**FINAL ADDITIONAL ANALYSIS
TO THE
SDSU 2007 CAMPUS MASTER PLAN REVISION FINAL EIR**

**SAN DIEGO STATE
UNIVERSITY**

AA3.14.12 RESPONSES TO COMMENTS

S-1-6

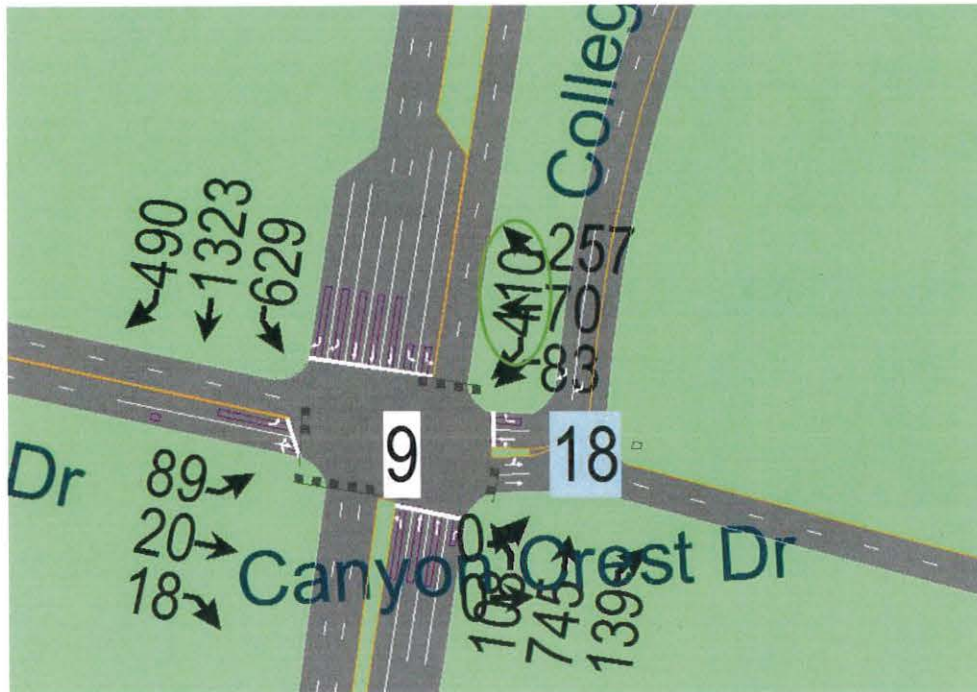
6. The Synchro files pedestrian walking time across College Avenue at Canyon Crest (node 9) should be revised. It should take about 35 seconds to walk across College Ave at Canyon Crest given the 3.5 seconds/foot acceptable pedestrian walking rate and the distance across of about 128 ft. The submitted Synchro files shows 7.0 + 15.0 walk time –total red phase of 22 seconds. Please update all intersection with the correct crossing times and resubmit.

S-2-5

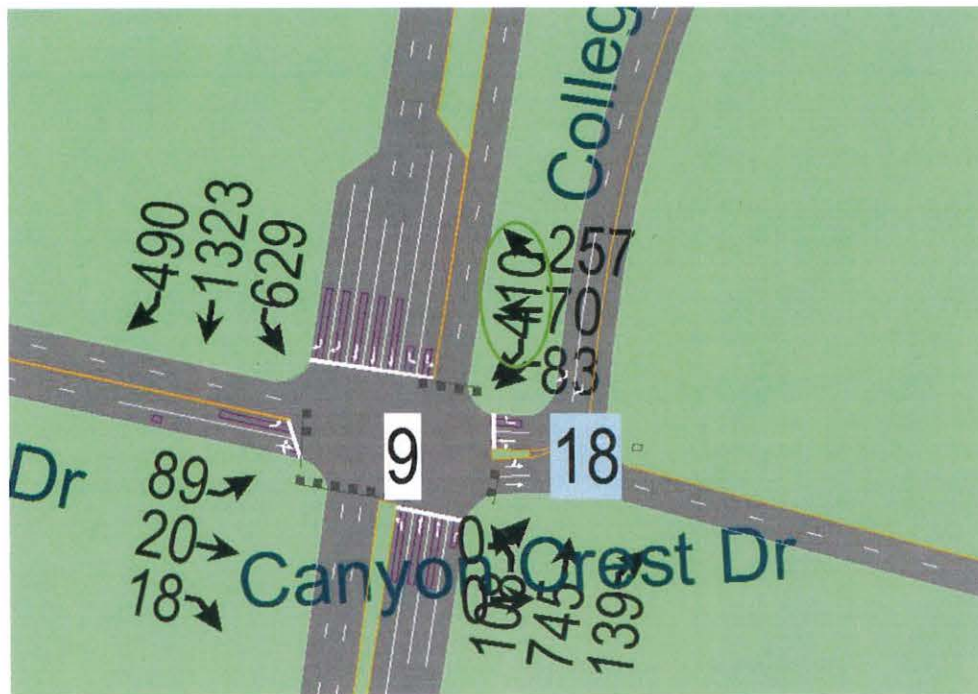
4. The Synchro files show pedestrian crossings on the wrong side of the College Avenue and Canyon Crest intersection. They are shown on the eastbound side crossing canyon crest where no pedestrian facilities exist. The Synchro files show zero pedestrian calls when this should be a busy pedestrian crossing. Please update with accurate crossings and pedestrian calls.
5. There is a missing volume segment on Alvarado Road shown as zero, but should be 410 vehicles/hour. This shows that there is no vehicle congestion on Alvarado Road when there is congestion (see graphic on next page).

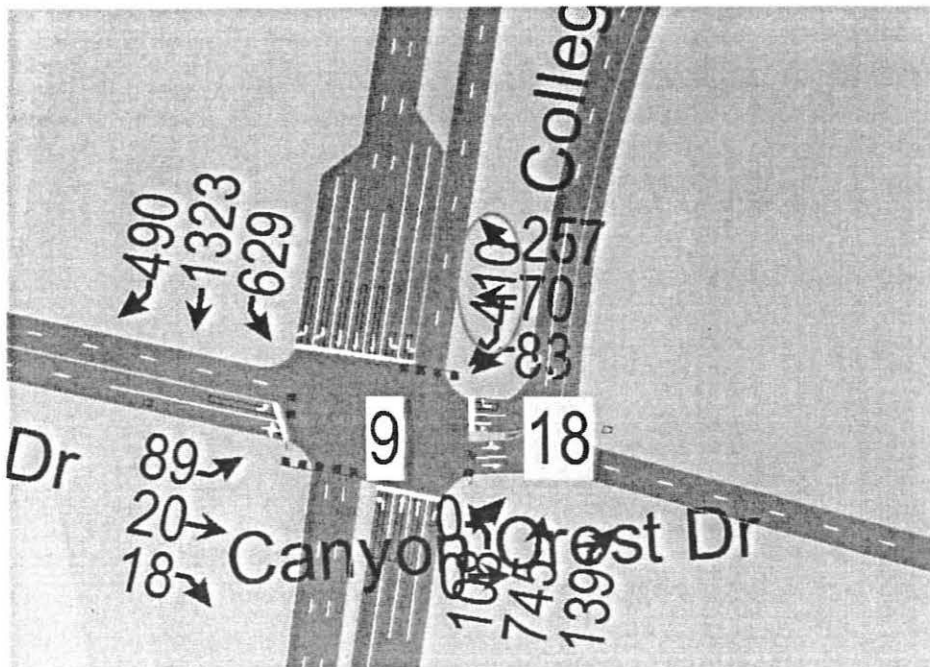
7. At the College Avenue and Canyon Crest intersection, Synchro files show a pedestrian crossing on the eastbound side crossing Canyon Crest where there are no pedestrian facilities. The Synchro files should be revised to show pedestrians crossing the Alvarado Road/E. Campus Drive. In addition, the Synchro files show zero pedestrian calls when this should be a busy pedestrian crossing.
8. There is a missing volume segment on Alvarado Road, which is shown as zero but should be 410 vehicles/hour. This shows no vehicle congestion on Alvarado Road when there currently is congestion. Please revise to show existing conditions. (see next page)

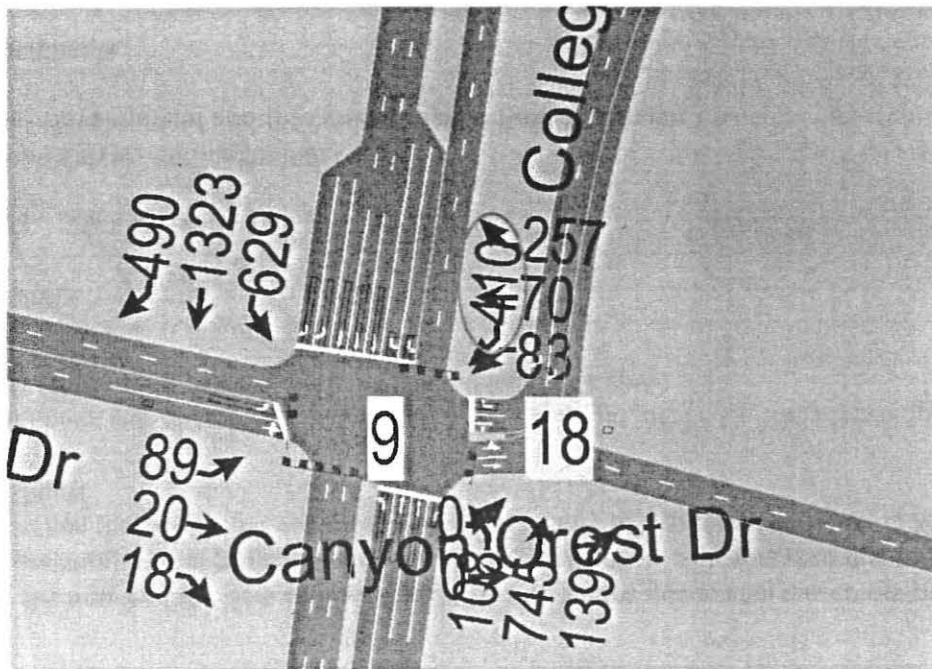
4. The Synchro files show pedestrian crossings on the wrong side of the College Avenue and Canyon Crest intersection. They are shown on the eastbound side crossing canyon crest where no pedestrian facilities exist. The Synchro files show zero pedestrian calls when this should be a busy pedestrian crossing. Please update with accurate crossings and pedestrian calls.
5. There is a missing volume segment on Alvarado Road shown as zero, but should be 410 vehicles/hour. This shows that there is no vehicle congestion on Alvarado Road when there is congestion (see graphic on next page).

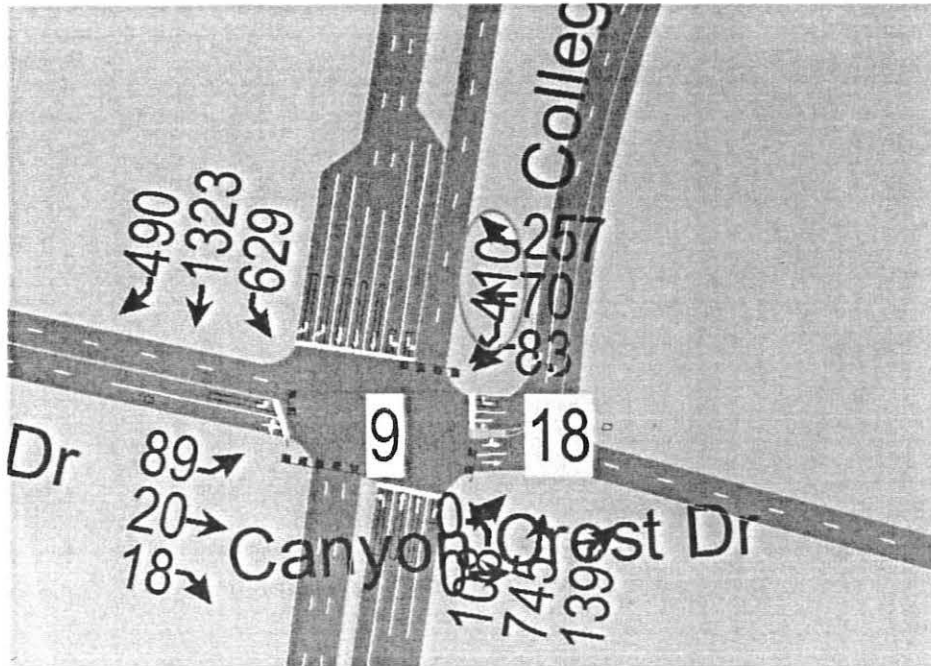
7. At the College Avenue and Canyon Crest intersection, Synchro files show a pedestrian crossing on the eastbound side crossing Canyon Crest where there are no pedestrian facilities. The Synchro files should be revised to show pedestrians crossing the Alvarado Road/E. Campus Drive. In addition, the Synchro files show zero pedestrian calls when this should be a busy pedestrian crossing.
8. There is a missing volume segment on Alvarado Road, which is shown as zero but should be 410 vehicles/hour. This shows no vehicle congestion on Alvarado Road when there currently is congestion. Please revise to show existing conditions. (see next page)

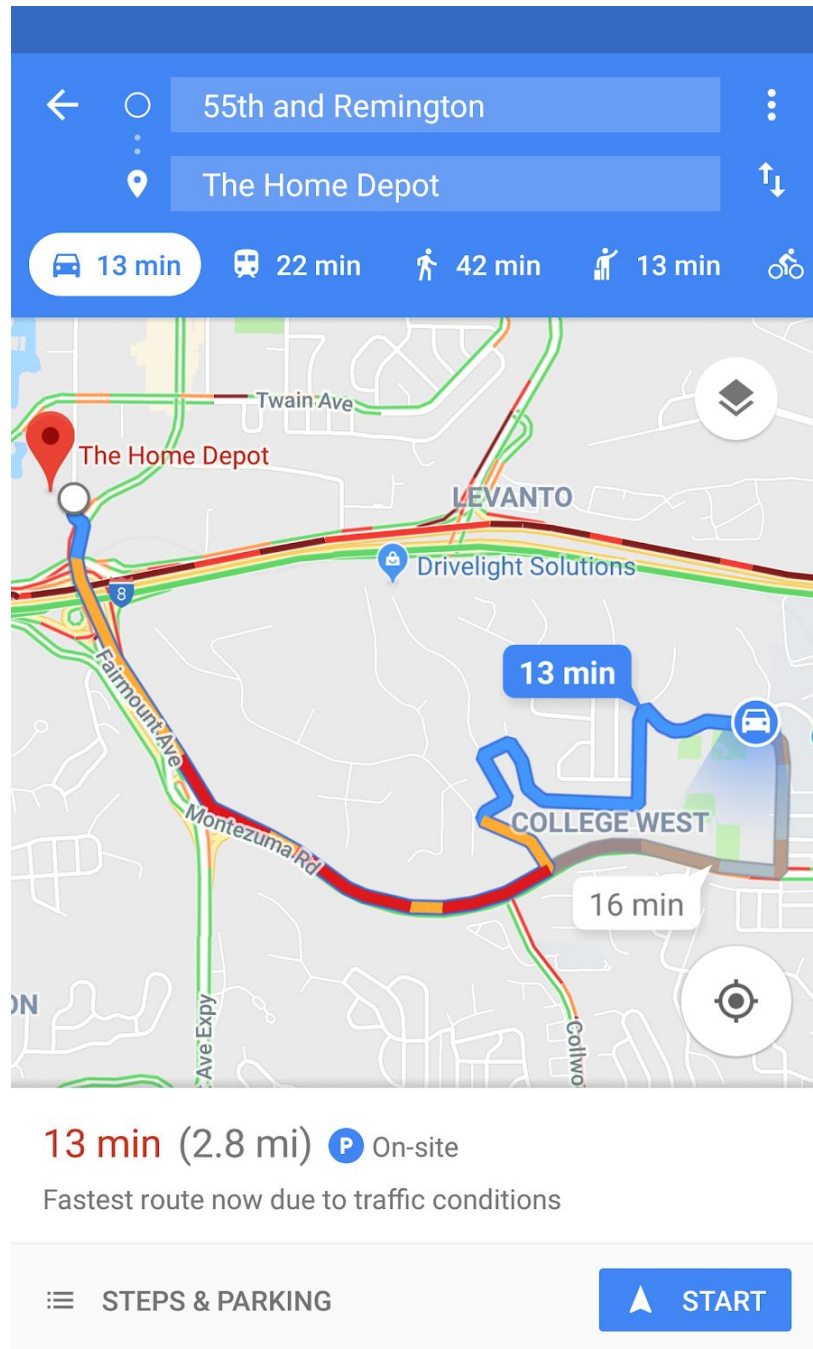
- e. GPS navigation with dynamic routing around congestion results in a redistribution of traffic such that congestion delays on alternative routes tend to be equalized. Drivers are advised to use alternate routes whenever that would save even a small amount of travel time (see Figure 1 for an example). Because this effect is ignored in the DAA, the distributional traffic impact of the project on various secondary and residential routes is understated.

- g. As illustrated in Figure 1, drivers seeking to travel to or from key on-campus locations (such as PS 12, Viejas Arena, the Aztec Recreation center, which will soon be expanded, or the New Student Housing project) and a point in Mission Valley near I-8 and Fairmount Avenue are frequently directed to use Remington Road, Hewlett Drive, College Gardens Court, and Yerba Anita Drive rather than endure the delays on 55th Street and Montezuma Road. Thus, although this route to and from the campus is apparently unknown to the planners and consultants at SDSU and LLG, it is well-known to any driver who uses a

As to the referenced Figure 1, which is a screenshot of Google Maps taken at 7:41 AM on February 22, 2018, showing that a route from the SDSU campus to Home Depot through the College View Estates neighborhood would take 13 minutes, as compared to 16 minutes for the route via 55th Street and Montezuma Road, the figure represents an isolated example. In response to the comment, LLG staff, on three consecutive days during peak morning and afternoon commute periods, utilized Google Maps to determine the route to the Montezuma Road / Yerba Santa intersection from a point on the west side of campus. In all instances, the 55th Street to Montezuma Road route was the suggested route to the intersection and not the route through the College View Estates. (See FAA Appendix AA, CVEA Related Materials, Google Maps Screenshot.)
